66321B-521-01

S E R V I C E N O T E

66321B with Option #521

Reliability Improvement of Instrument

CORRECT J207 PLACEMENT – alignment to within $< 0.3\text{mm}$

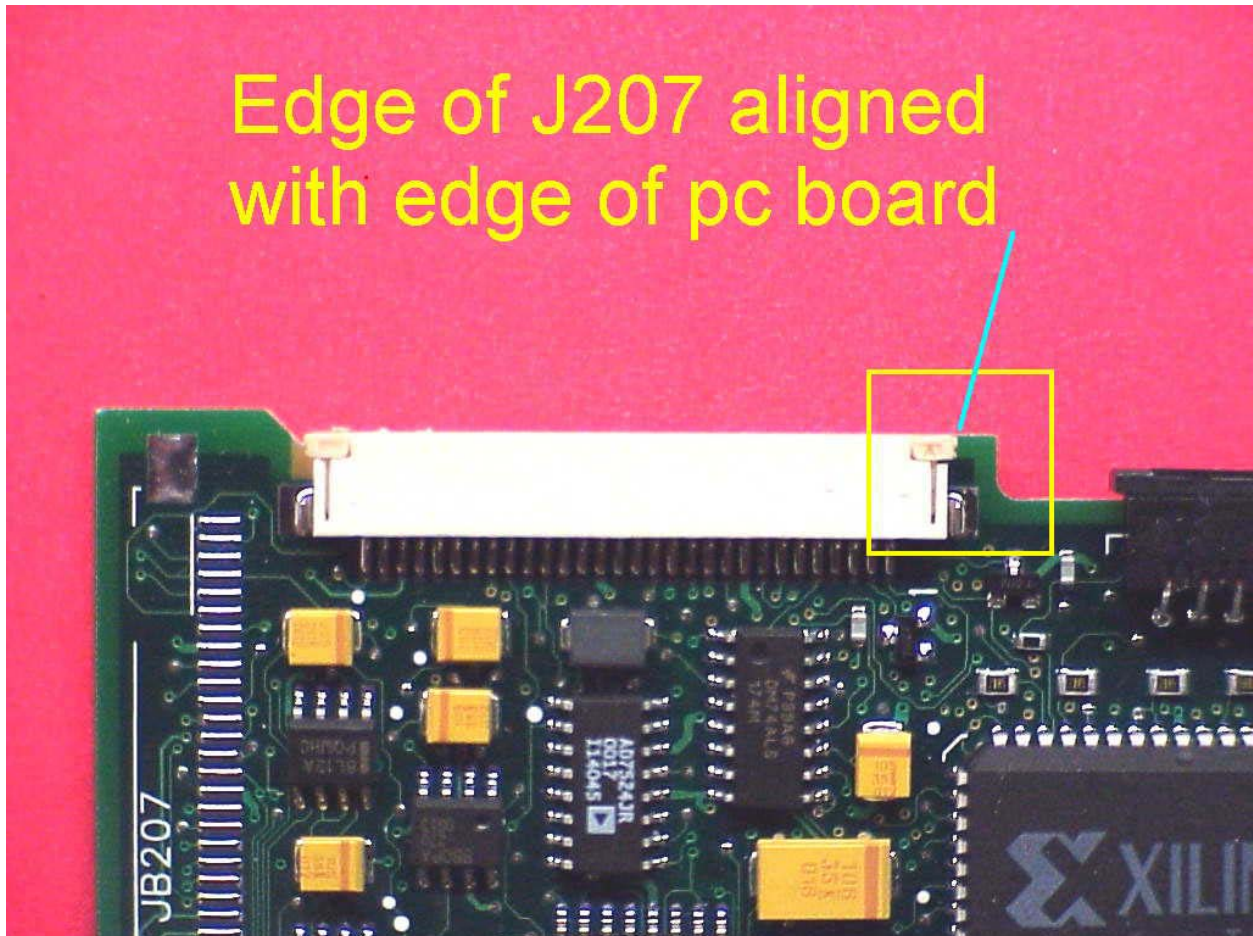
Latent product failure due to misplaced connector J207 on SMT assembly 5064-0018 (GPIB/RS232 interface). Misplacement of J207 could lead to inadvertent contact/shorting of exposed feed-throughs on SMT board. Ultimately, resulting in over-stress of components of damage to SMT board components. Resulting contact could degrade useful life of instrument.

Picture shows connector aligned to edge of SMT board to within $< 0.1\text{mm}$

- 1) Compare placement of J207 to attached photos. Instruments with a “misplaced” J207 should be returned to Agilent for warranty repair.
- 2) Instruments returned to the Service Center for routine calibration should be inspected for this potential defect. Defects should be addressed using Agilent’s unit exchange process with costs being charged to warranty.
- 3) The factory has modified production documentation to include visual inspection and specific electrical testing for this potential short.
- 4) Factory is maintaining feedback to SMT board supplier regarding quality of assembly.

INCORRECT J207 PLACEMENT – misaligned by $> 0.3\text{mm}$

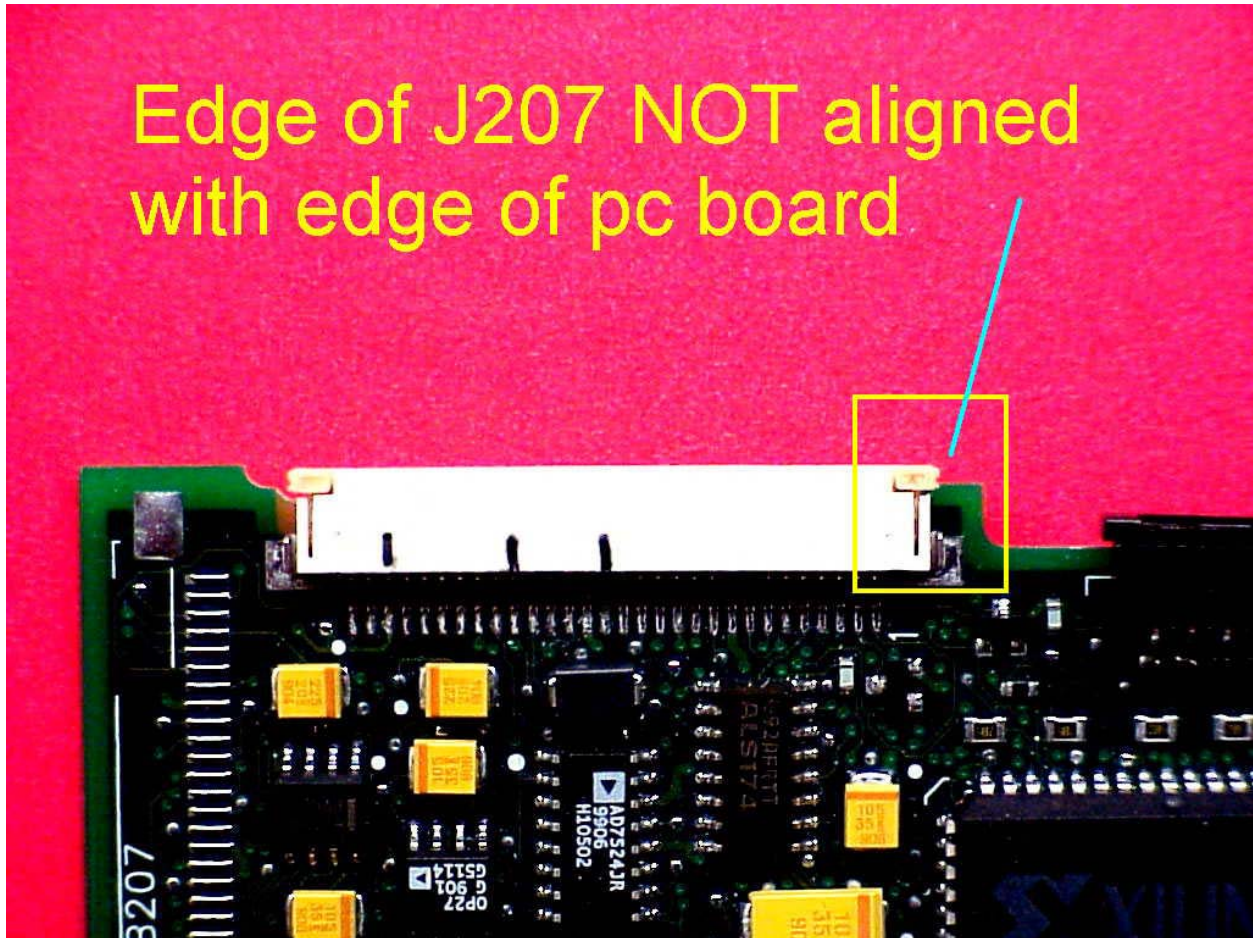
Picture shows connector extending past edge of SMT board by $>1.2\text{mm}$
